4. CASE 23.074, 41 WHITMARSH STREET, Alfred M. Williams House, c1889 (NORTH ELMWOOD)

Proposal: The scope of work proposed consists of Minor Alterations and includes:

Recommendations: The staff recommends the PHDC make the following findings of fact:

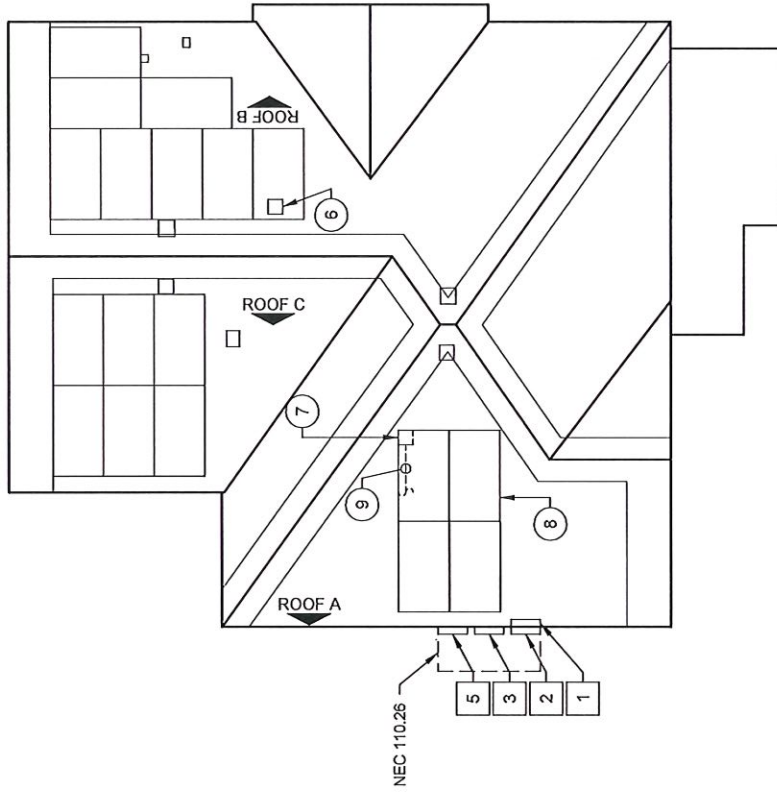
- The applicant appeared at the June 26th meeting where it was discovered that the panels had already been installed; The Commission continued the matter with suggestions that panels should be reorganized from the proposed/installed installation. The applicants have submitted a revised layout that proposes 18 panels (previously was 22): four panels on Roof A (SW slope), eight panels on Roof B (NE slope) and six panels on Roof C (NW slope). Roof A would be the most visible from the public rights-of-way;

- The modifications as proposed may meet Minor Alterations: Solar Energy Systems Guidelines, Section 2, in the following manner: Panel layout shall be sympathetic or appropriate to design and scale of building. Rectangular configurations are preferred, with ample setback from edge of roof, dormers, chimneys, etc. (2.A); Panels shall be installed parallel to the existing roof slope and matched as closely as possible to the roof plane (2.B); Panels shall be installed without destroying or replacing original or historic materials or significantly compromising or altering the building's structural integrity (2.C); Panels shall be compatible in color to existing roofing insofar as possible (2.D); Installation of panels shall be as inconspicuous as possible when viewed from public right-of-way (2.E); Installation shall be reversible. Panels shall be removed when no longer viable or functioning and roofing restored to pre-existing conditions (2.F); and,

- b) The modifications as proposed meets Minor Alterations: Solar Energy Systems Guidelines, Section 2, and the application is considered complete; and,

- c) The work as proposed is in accord with PHDC Standards 8 & 9 as follows: 8) the work will be done so that it does not destroy the historic character of the property or the district as they are not on the primary elevation and will be minimally-to-not visible from the public rights-of-way; and, 9) Whenever possible... alterations to structures shall be done in such a manner that if removed in the future, the essential form and integrity of the structure and the site will be unimpaired.

Staff recommends a motion be made stating that: The application is considered complete. 41 Whitmarsh Street is a structure of historical and architectural significance that contributes to the significance of the North Elmwood local historic district, having been recognized as a contributing structure to the Elmwood National Register Historic District. The Commission grants Final Approval of the proposal as submitted as the proposed alteration is appropriate having determined that the proposed alteration does not destroy the historic character of the property or the district and are historically and architecturally compatible with the property and district as the proposed alteration meets Minor Alterations: Solar Energy Systems Guidelines, Section 2, is reversible and will not have an adverse effect on the property or district as they are not on the primarily on secondary elevations and will be minimally visible from the public rights-of-way (Standards 8 & 9), and the recommendations in the staff report, with staff to review any additional required details.
